ATA Security feature Set Clarifications

To: T13 Technical Committee
From: Jim Hatfield
Seagate Technology
(with Jeff Wolford: Hewlett-Packard)
389 Disc Drive
Longmont, CO 80503
Phone: 720-684-2120
Fax: 720-684-2722
Email: James.C.Hatfield@seagate.com
Date: June 21, 2006

Proposal

I propose that the following be incorporated into ATA/ATAPI-8 ACS as a full replacement for the referenced sections.

Figure 1 - Security State Diagram

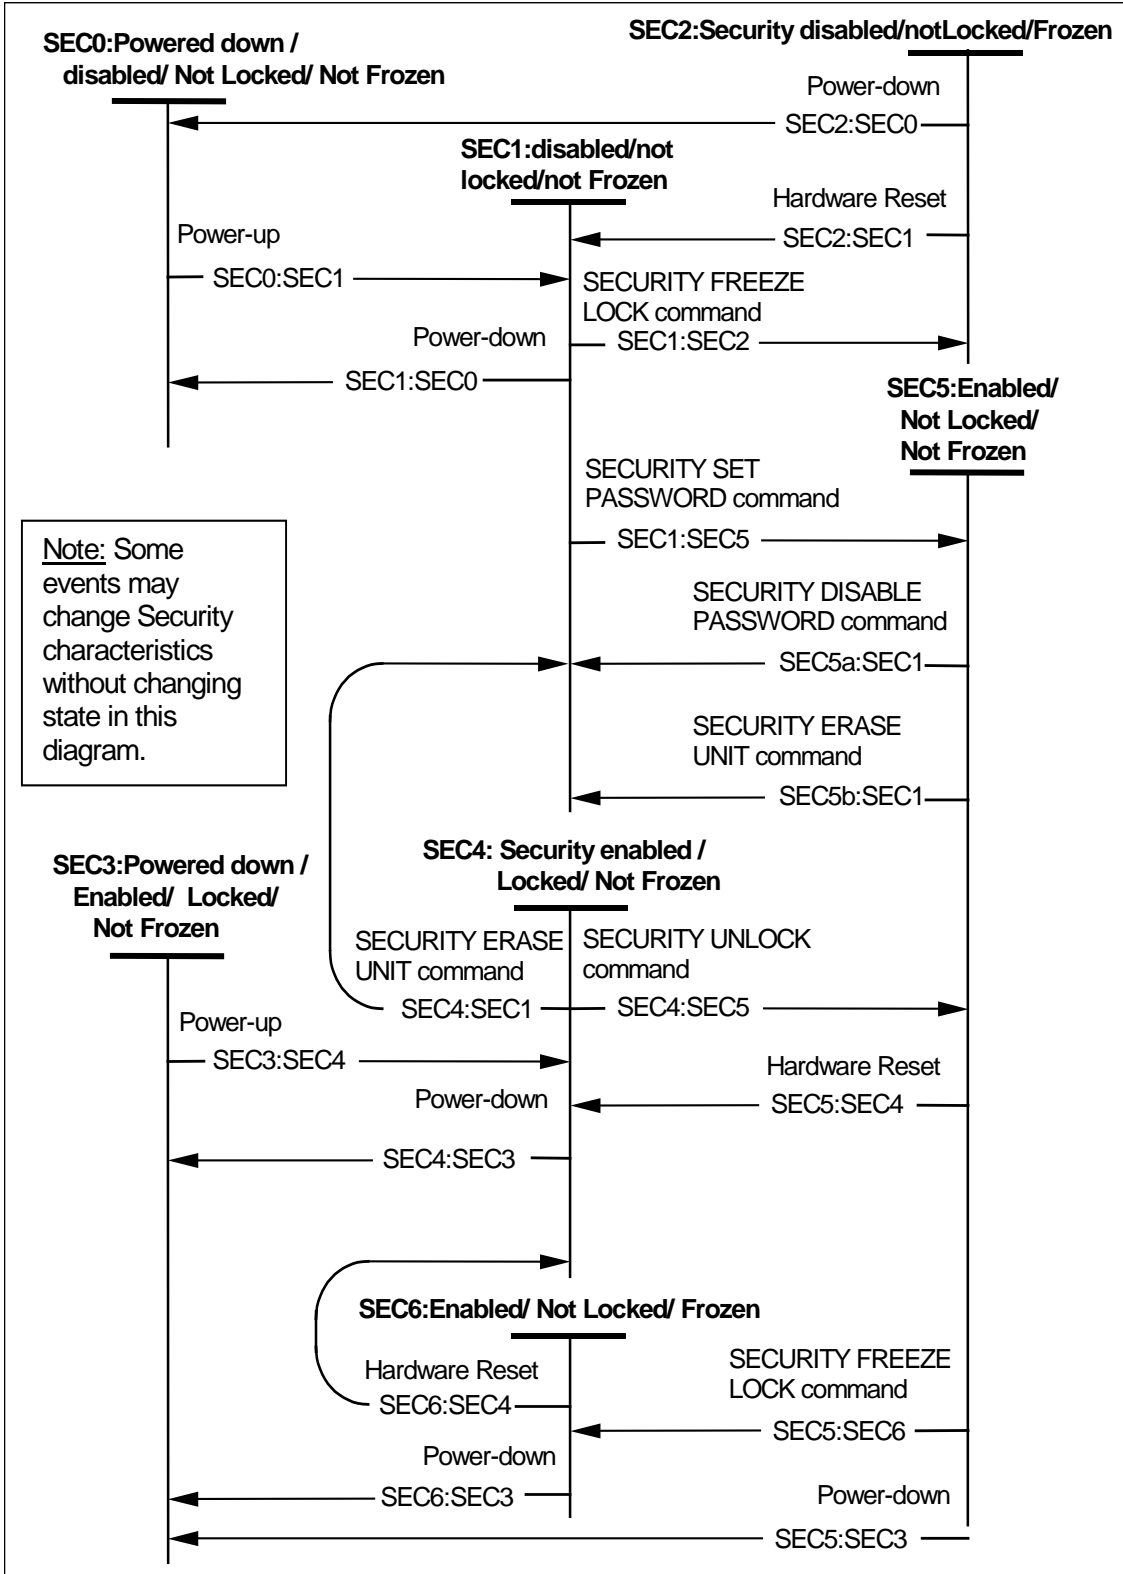
- 1) Shall hardware reset be removed as an exit from Frozen states ?
 - a. Resolution:
 - i. No. fix the one text reference (in the feature description) that is bad. The figure is correct.
 - ii. Create an informative note (where the text is being corrected) saying that the host 'should' reissue a SECURITY FREEZE LOCK after hardware reset.
- 2) May SECURITY ERASE UNIT and SECURITY DISABLE PASSWORD be allowed to decrement the attempt counter for failed password comparisons ? If so, from which states may this be allowed ?

- ii. Make sure that e05162r0 (approved) is integrated with this clarifications document.
 - iii. Consider Ignoring the password is the be moved to the ‘security enhancements’ proposal.
- 9) In the text following the state diagram, shall each reference to each state name ALSO have the tags “enabled/locked/frozen”, etc. that is appropriate to each state ?
 - a. Resolution: do not keep all the tags with each reference
- 10) Incorporate the Visio version of the state diagram
